SAFETY RECALL BULLETIN

NHTSA RECALL 20V545

AUTOCAR, LLC SAFETY RECALL ACX-2006

Autocar has determined that a safety defect may exist in the routing of the methane detector sensor harness and/or the methane detector circuit fuse on certain 2019 Xpeditor vehicles which could lead to an over-current condition.

Figure 2, Methane detector fuse

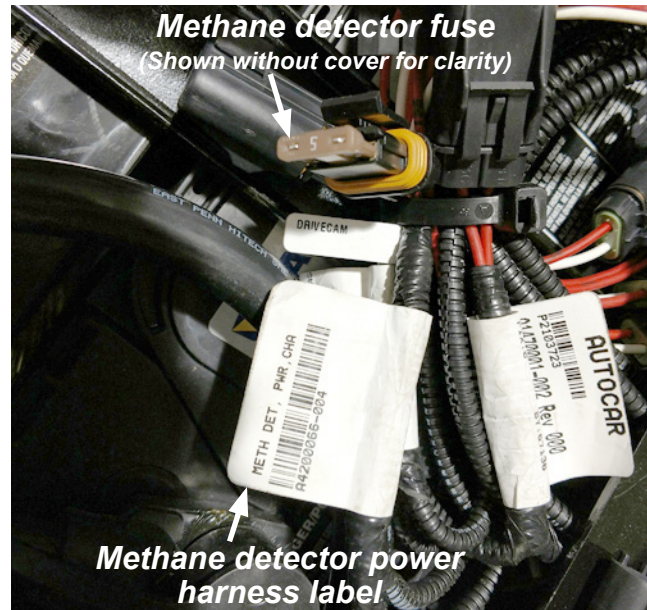
4. Locate the methane detector power harness in-line fuse holder (see *Figure 2*).

5. Remove the in-line fuse holder cover and set aside for re-installation, remove the existing fuse from the methane detector power harness in-line fuse holder and discard.
6. Install a 3 AMP ATC fuse into the methane detector power harness in-line fuse holder and re-install the in-line fuse holder cover that was set aside in step 5.

Figure 3, Cab in the raised position

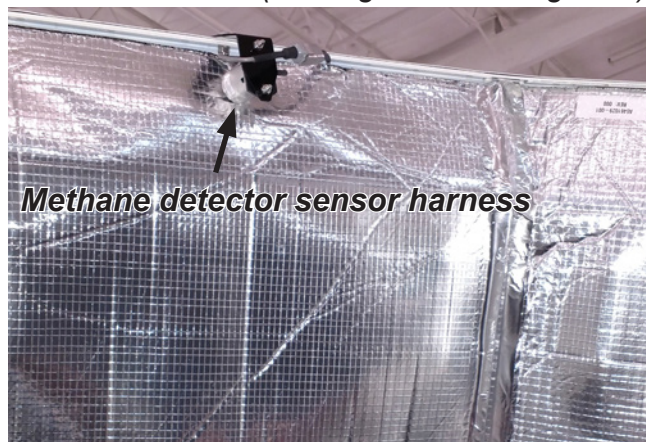
8. Locate the methane detector sensor in the engine tunnel area of the raised cab, inspect the methane detector sensor harness (see *Figure 3 and Figure 4*).

Figure 5, Methane detector sensor harness (damaged)

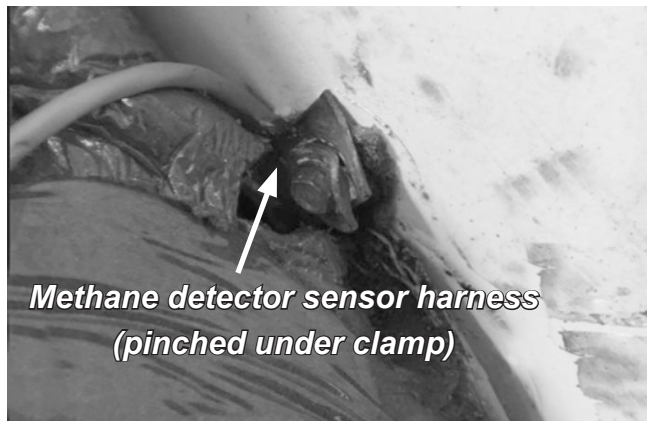
If damage is found to the methane detector sensor harness, contact Autocar technical support at 888-218-3611 for assistance with repair (see *Figure 5* and *Figure 6*).
